ADDENDUM #1

Hasty Community Center Renovations – Bid #2017-008

City of Auburn, Maine

28 November 2016

Sheet Number:
A1.1

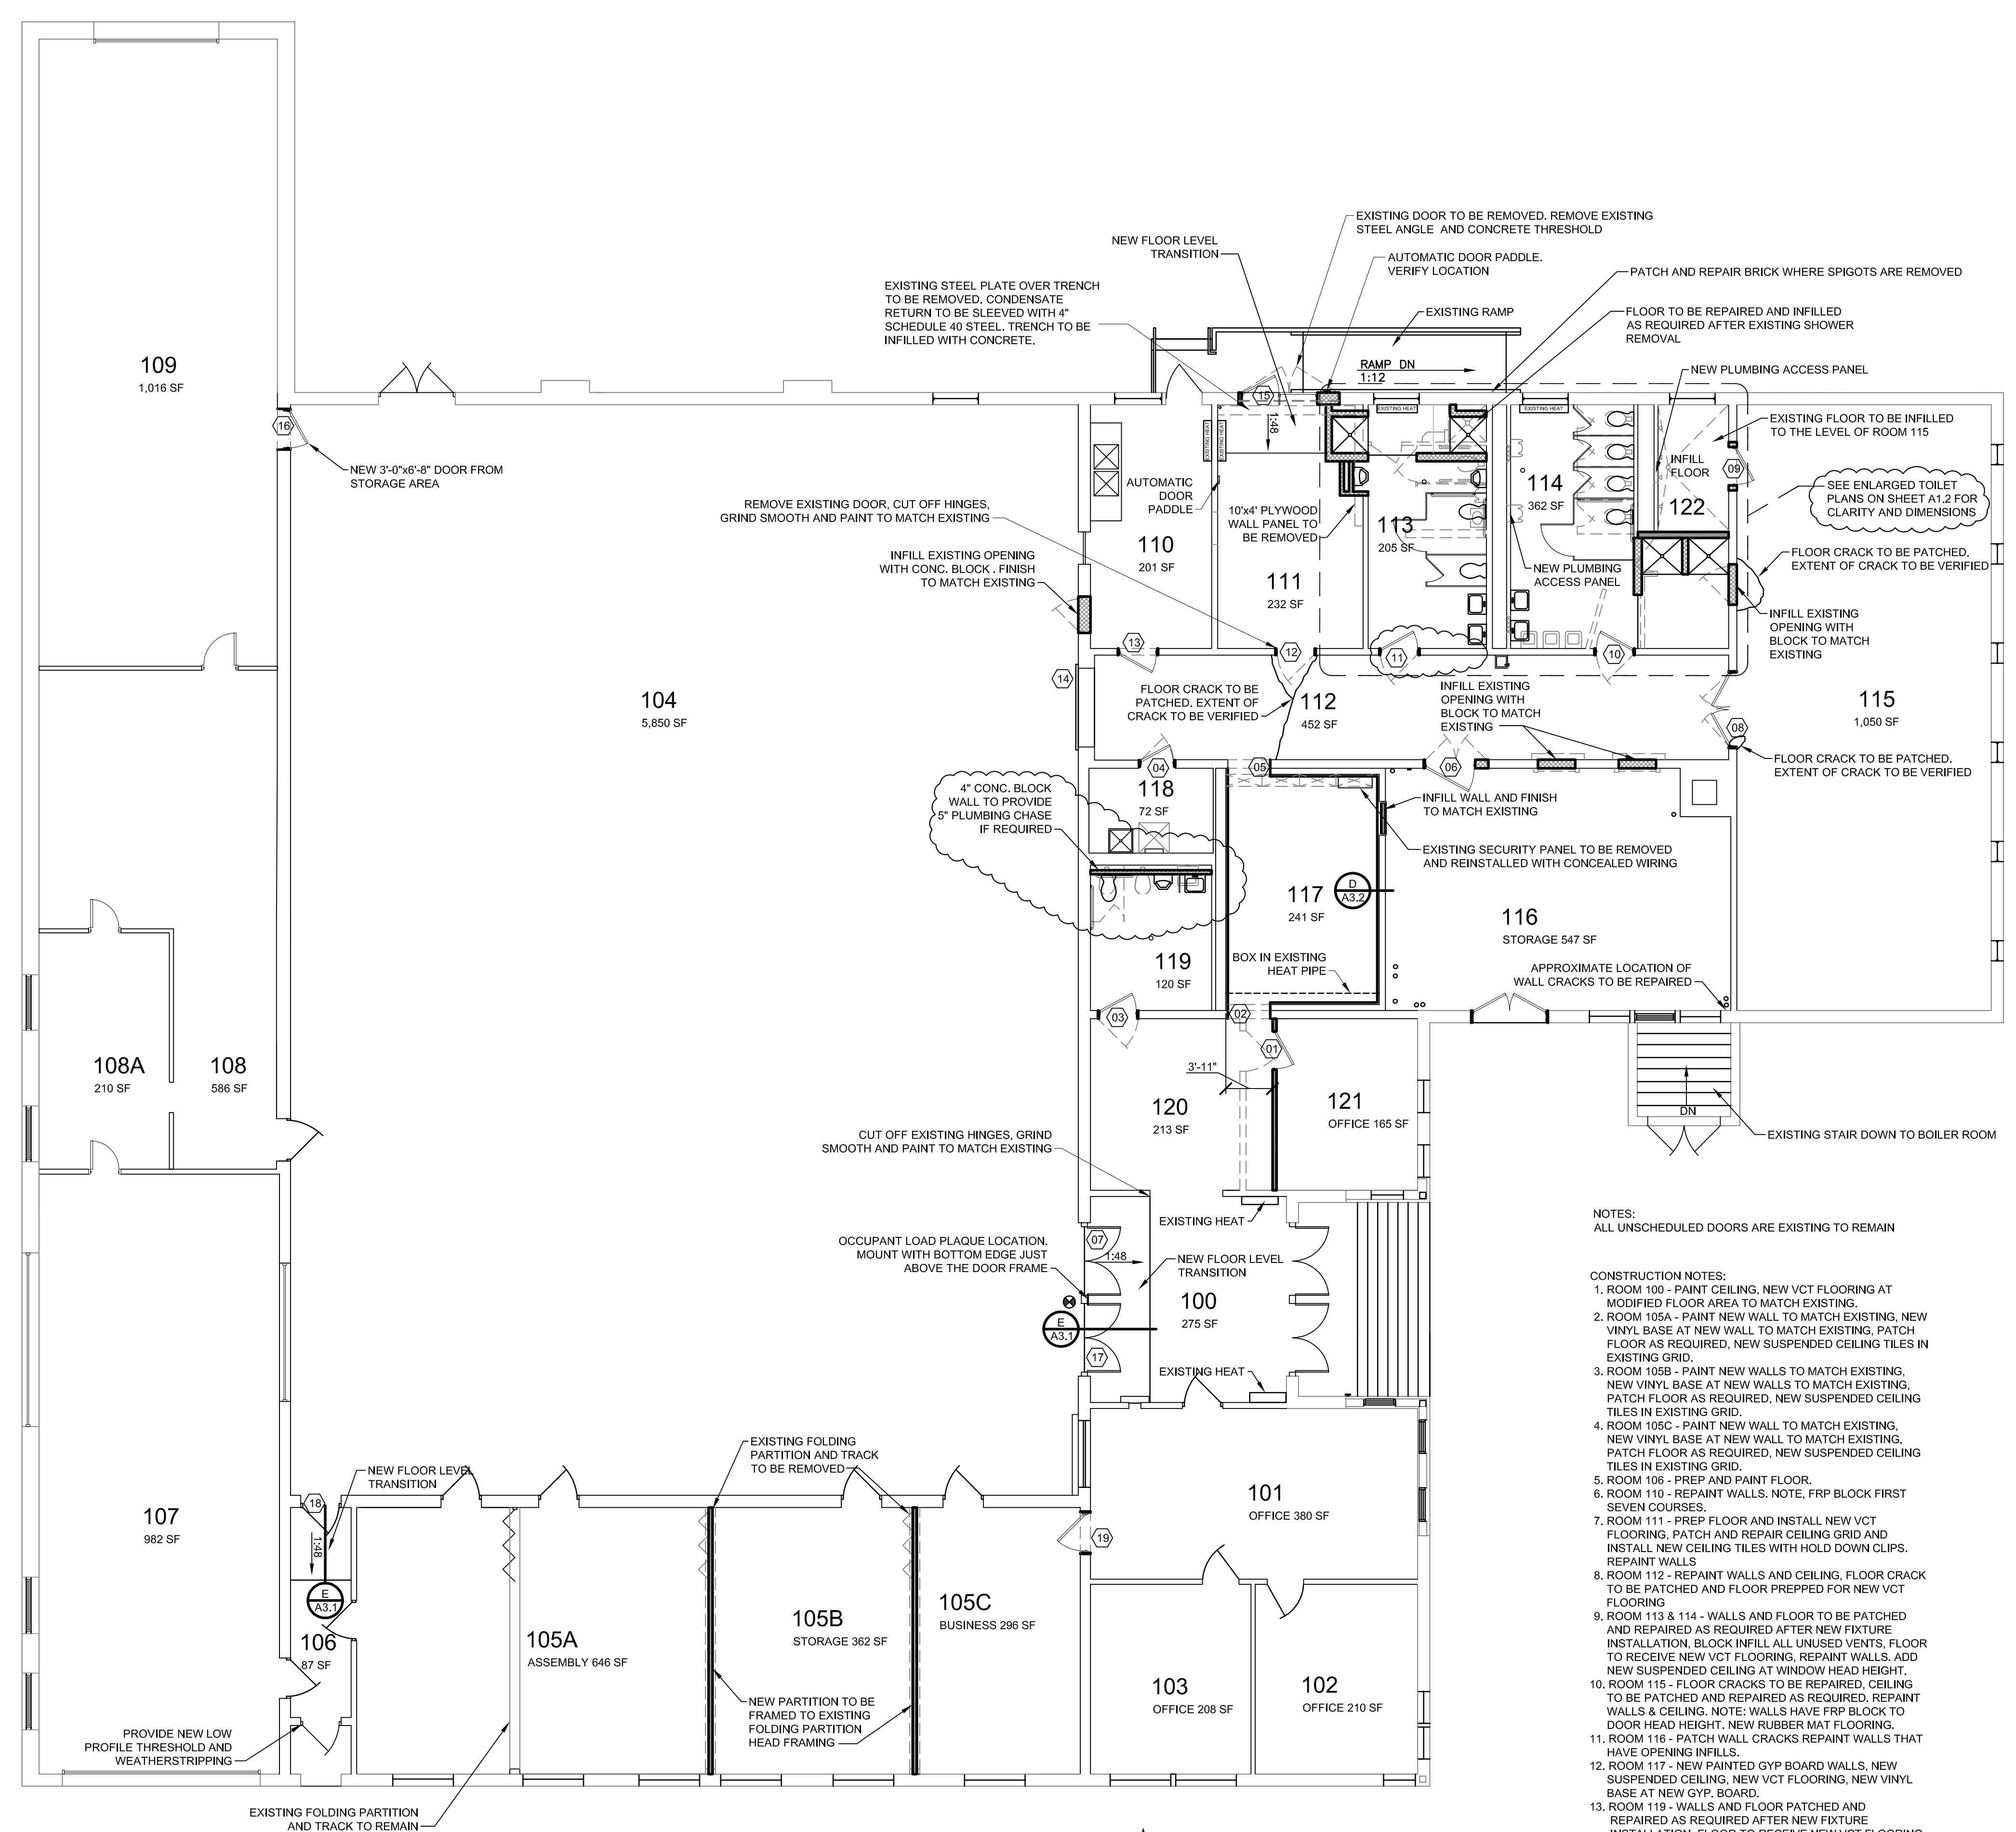
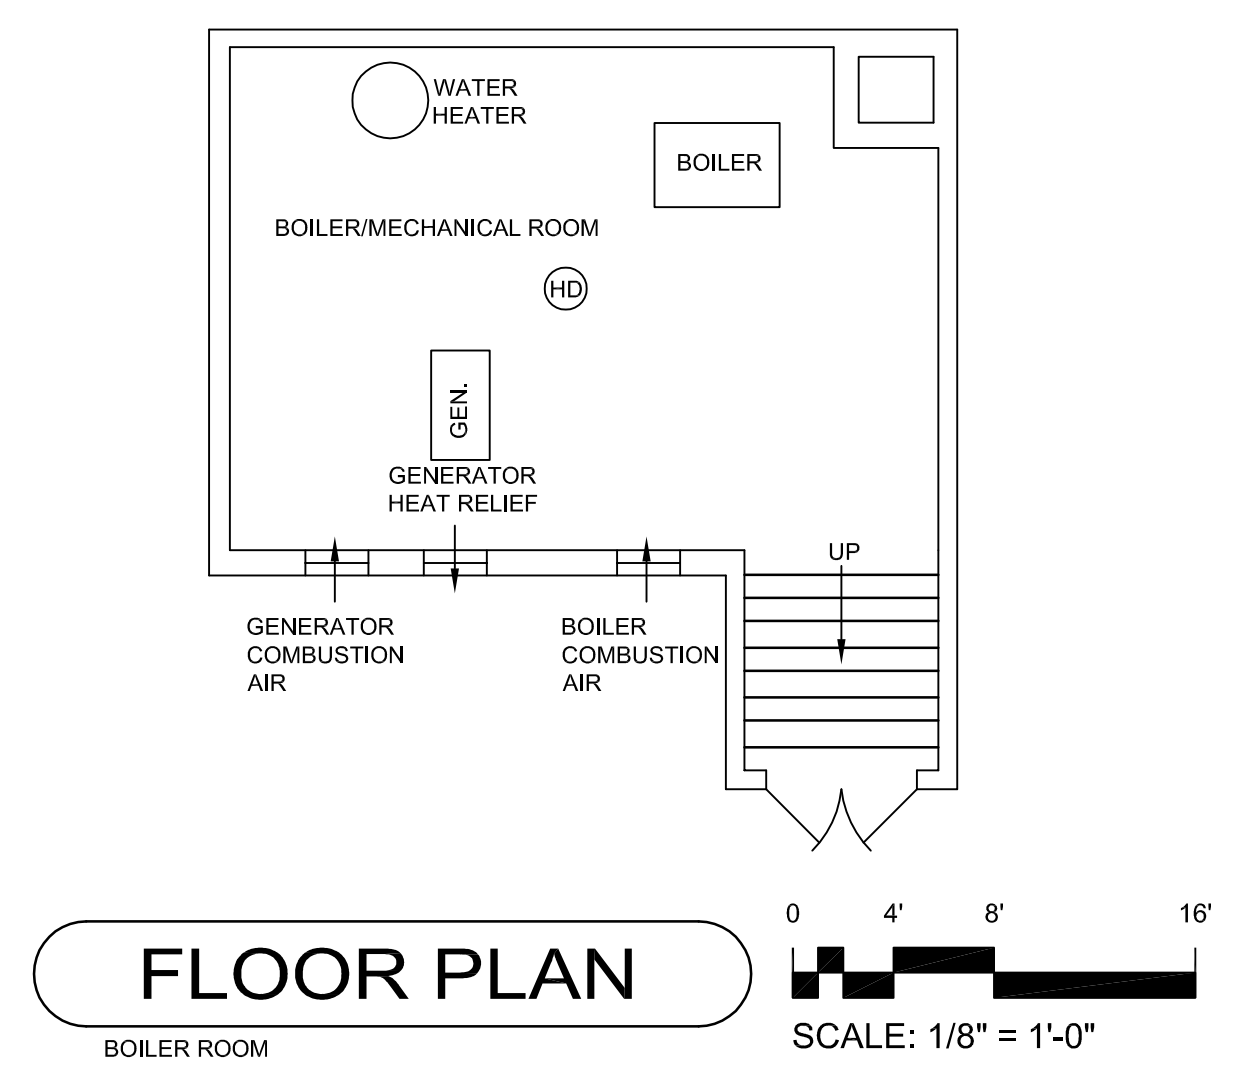
1. **Drawing A1.1: DELETE** drawing A1.1 in its entirety. **REPLACE** with the attached revised drawing A1.1. Revisions include modifications to the restroom walls, toilet partitions and plumbing fixture layouts to accommodate a less complicated plumbing installation.
2. **Drawing A1.2: DELETE** drawing A1.2 in its entirety. **REPLACE** with the attached revised drawing A1.2. Revisions include modifications to the restroom walls, toilet partitions and plumbing fixture layouts to accommodate a less complicated plumbing installation.

8. *Question:* Several notes on A1.1 refer to an “FRP” block. Can you clarify what this refers to?

Answer: FRP Block is concrete block with a Fiberglass Reinforced Plastic coating on the exposed face. Existing FRP (as noted on the drawings) that is to remain is to be painted with the products specified and block in-fills are to be standard concrete block.

Sheet Number:
A3.1

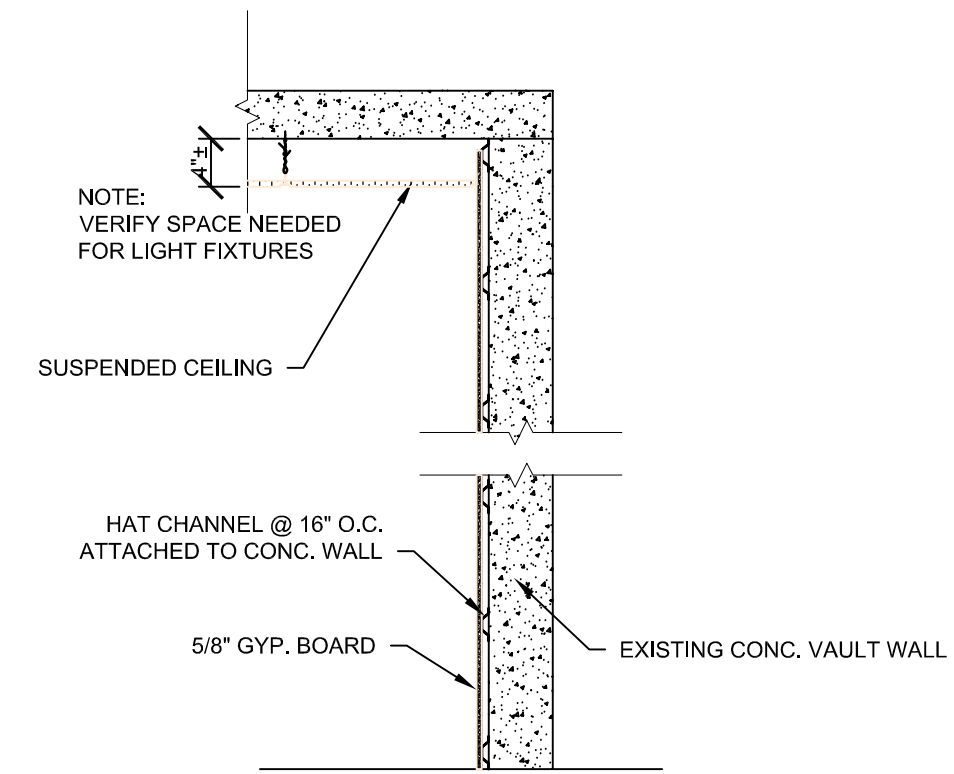
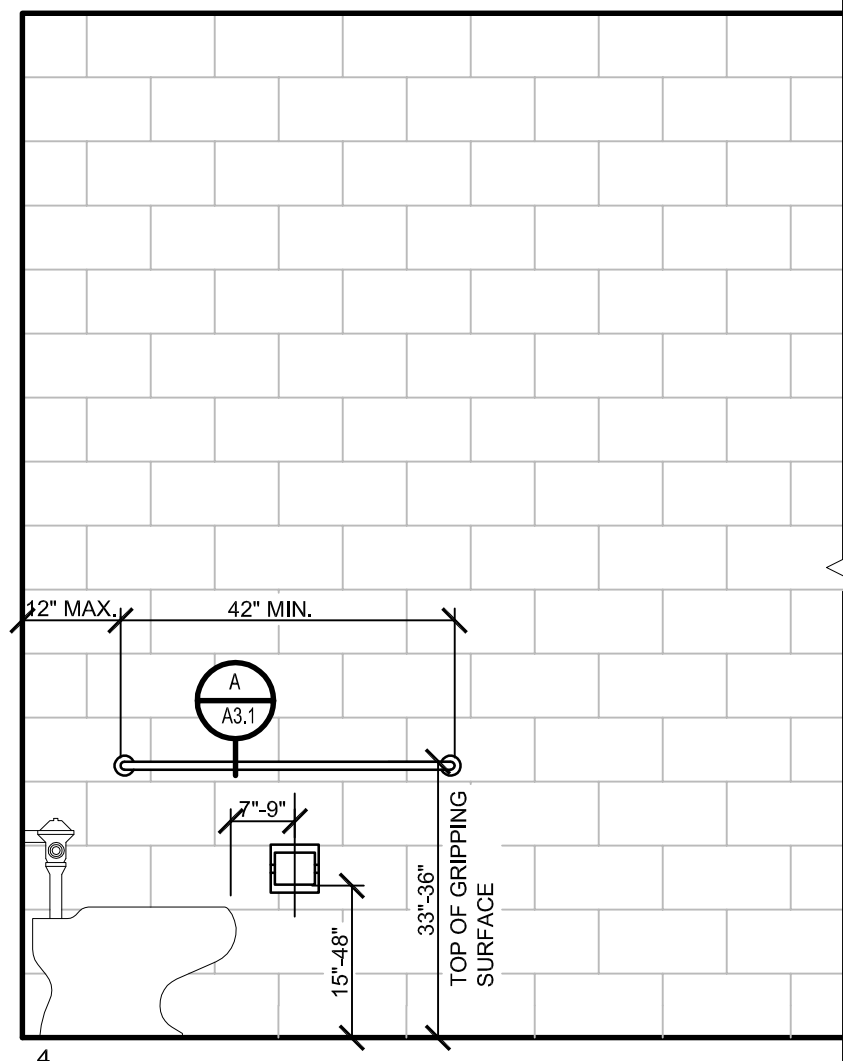
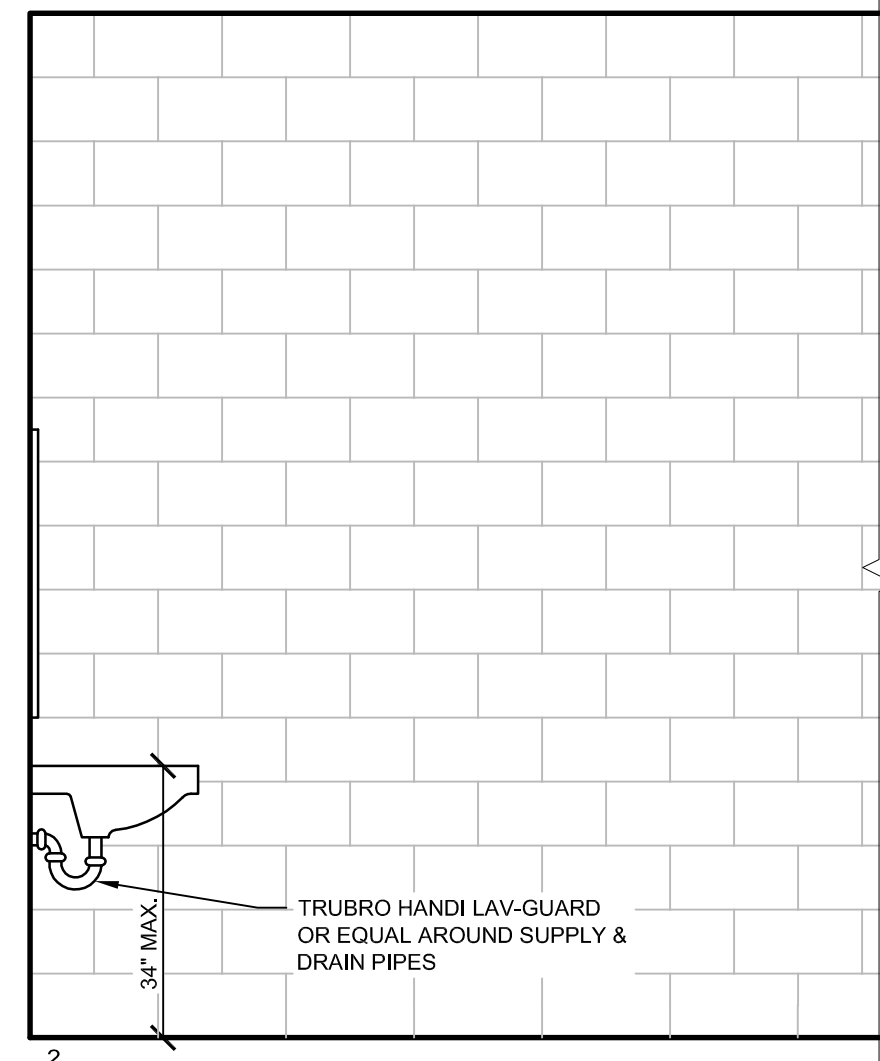
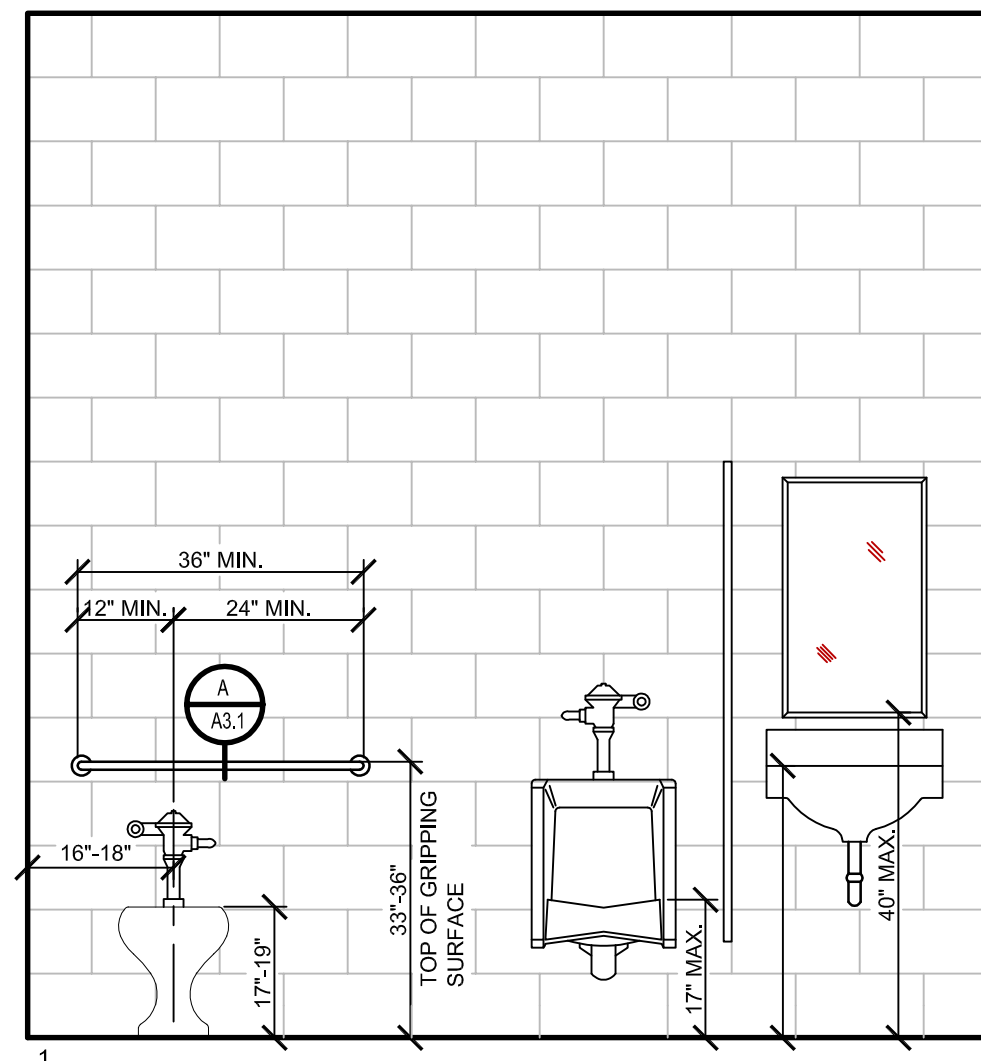
3. **Drawing A3.1: DELETE** drawing A3.1 in its entirety. **REPLACE** with the attached revised drawing A3.1. Revisions include modifications to the restroom elevations including walls, toilet partitions and plumbing fixture layouts to accommodate a less complicated plumbing installation.
